DEPARTMENT OF TRANSPORTATION

49 CFR Parts 567, 571, 574, 575, and 597

Tire Safety Information

ACTION: Final rule; response to petitions for reconsideration.

Figure 1

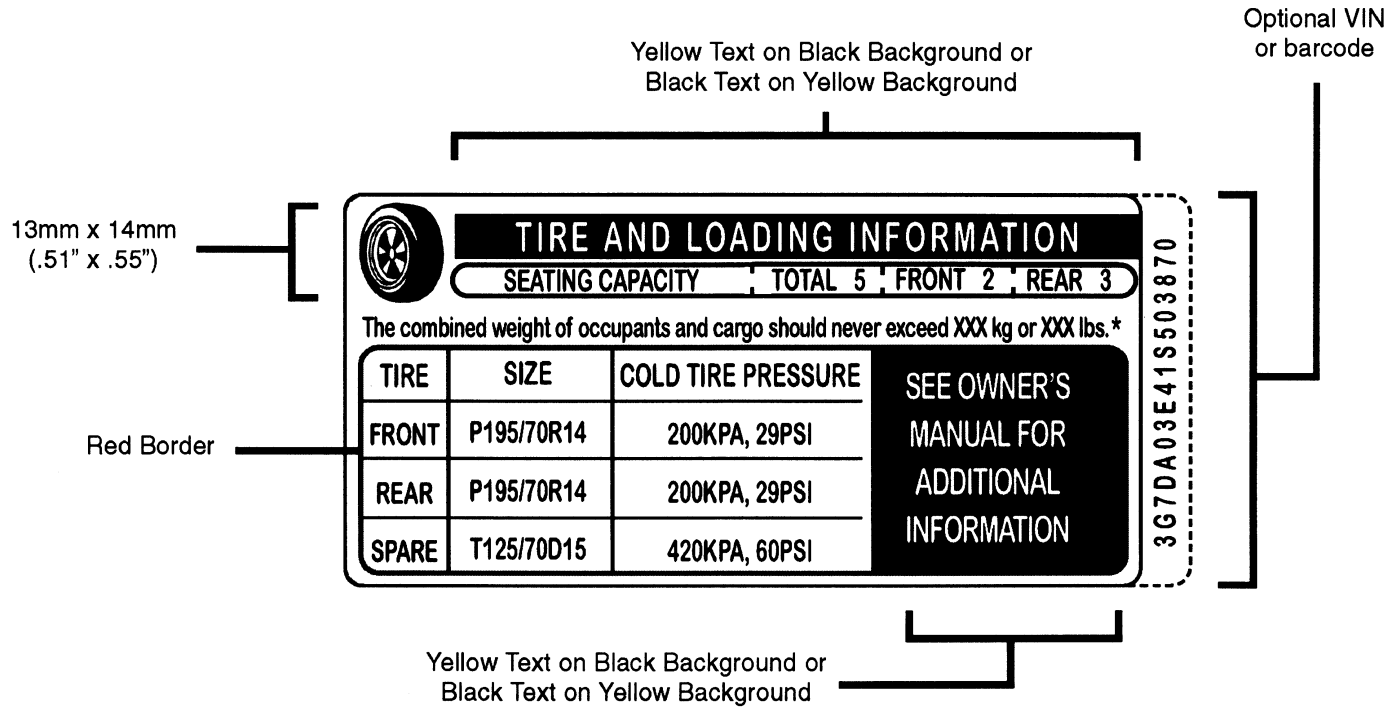
- The chart within the Vehicle Placard of Figure 1 is re-formatted to be identical to the chart within the Tire Inflation Pressure Label of Figure 2.
- Reference to “occupants” is be removed from trailer placards and trailer owner’s manuals, and
- Incomplete and intermediate vehicle manufacturers are not allowed to affix a placard to an incomplete vehicle.

¹⁴ We note that Figure 2 of the November 2002 final rule incorrectly contained the load index and the speed category symbol. This document contains corrected figures depicting the tire information label and the tire placard. The load index and the speed category symbol have been excluded from the revised figures.

Vehicle Placard in Figure 1 so that the chart within the placard is formatted identically to the chart within the Tire Inflation Pressure Label in Figure 2. We conclude that the chart currently found within Figure 2 is better organized than the chart currently found within Figure 1. We believe that the uniform use of a single chart format will enable consumers to better understand the necessary tire information. Additionally, in those rare instances where a vehicle is equipped with front and rear tires of different sizes, the chart format from the Figure 2 will allow a manufacturer to identify different tires sizes for front and rear tires. The Vehicle Placard in Figure 1 has been revised accordingly. This rule contains updated examples of the Vehicle Placard and the Tire Inflation Pressure Label.¹⁵

* For trailers, this statement should read:
The weight of cargo should not exceed XXX kg or XXX lbs.
